**Object : PRODUCT MODIFICATION ANNOUNCEMENT**

TPC Part number : FZX06-8381--C

New TPC part number : FZX06-8381--D

Outline Drawing

FZX06-8381--D

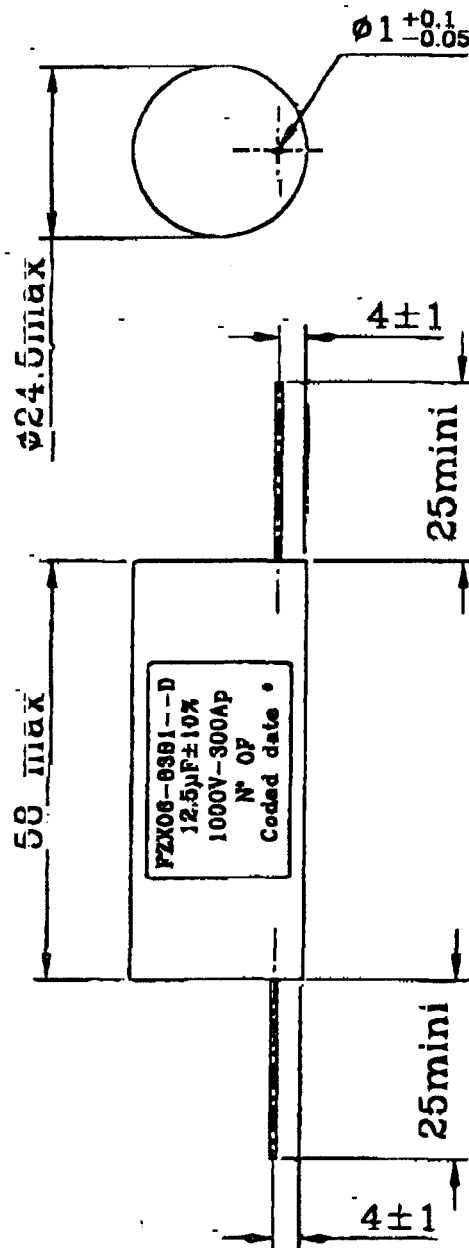
Substitution of our old discharge technology by our new discharge technolgy.

Technical datas aren't change.

Part Number will pass to : FZX06-8391--D

| e    | Pass to ind. D (new discharge technology)                                       | 30/08/02 | LP   |
